3 Volt Intel StrataFlash[®] Memory

28F128J3, 28F640J3, 28F320J3

Specification Update

Order Number: 298130-015

Figure 1. AC Waveform for Standard Word/Byte Read Operations

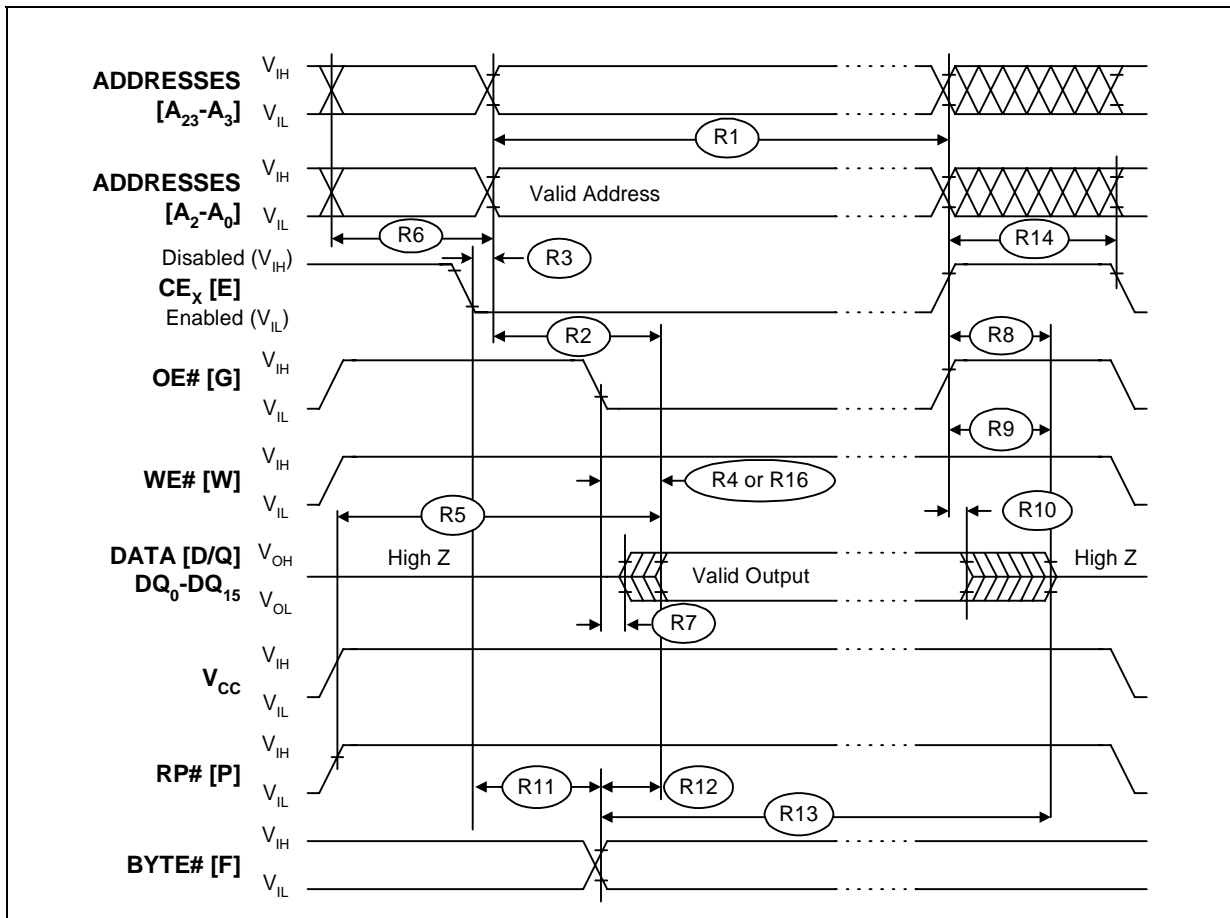
Problem: Devices need the parameter $t_{ELQX} = 150$ ns minimum. CE low to output in low Z (t_{ELQX}) is designated as R6 in Figure 1, in this Specification Update revision.

Problem: Devices need the parameter $t_{ELAV} = 500$ ns maximum. Chip Enable to Address Valid (t_{ELAV}) is designated as R3 in Figure 1, in this Specification Update revision.
